Appendix A  
Technical Report  
on

EVALUATION OF BLOCK MASONRY WALLS AT  
PALO VERDE NUCLEAR GENERATING STATION

October 1986

Fig. 2 - Test Data on the Relationship Between Modulus of Elasticity and Masonry Compressive Strength (7)

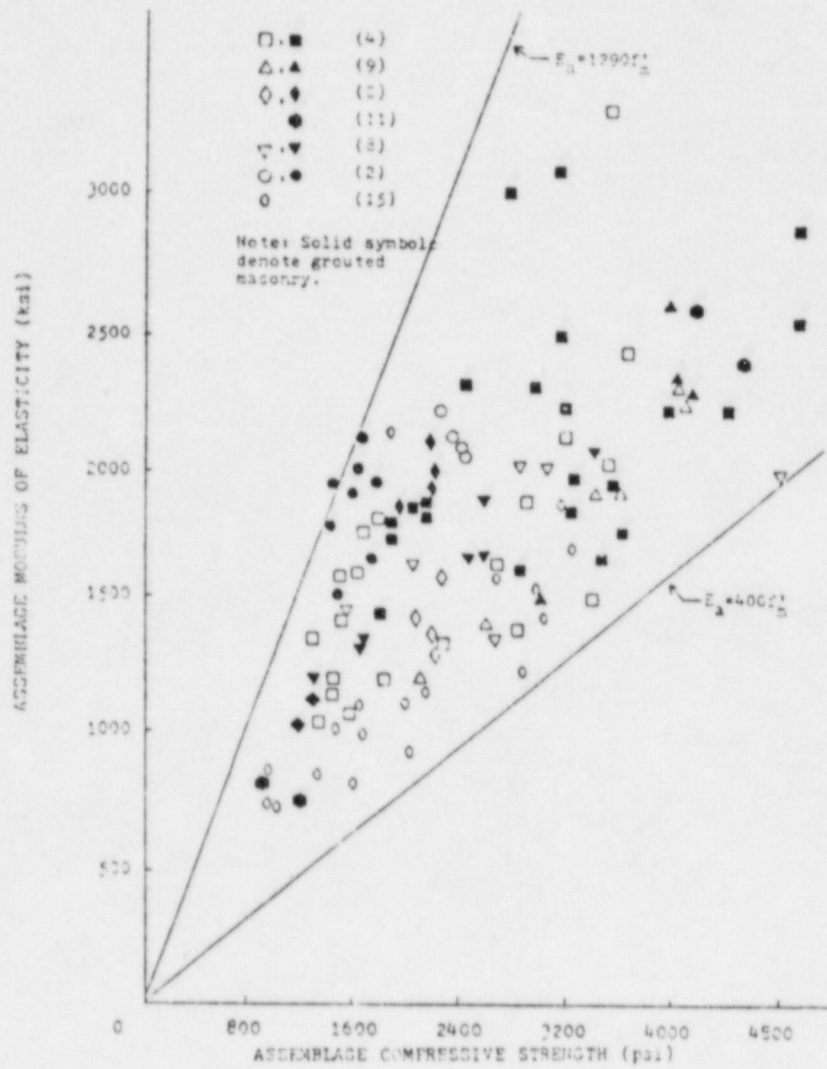
The modulus of elasticity as calculated from the stress-strain curve is highly sensitive to the method of testing, the shape of the prism, and the stress level at which it is calculated. As can be seen in Fig. 2, high variation in the ratio of the elastic modulus to the compressive strength is reported (7).

The Atkinson and Noland report (8) and other studies (7) show that a more realistic ratio of the modulus of elasticity to compressive strength would be in the range of 500 to 700.

Based on a conservative yet realistic ratio of modulus of elasticity to compressive strength of 500, the elastic modulus of PVNGS walls would be  $500 (1500) = .75 \times 10^6$  psi. This value is 50 percent lower than the minimum value used in Bechtel calculation. This would result in a 33 percent reduction in frequency which will significantly increase the response of the wall due to its proximity to the amplified region of the response spectra.
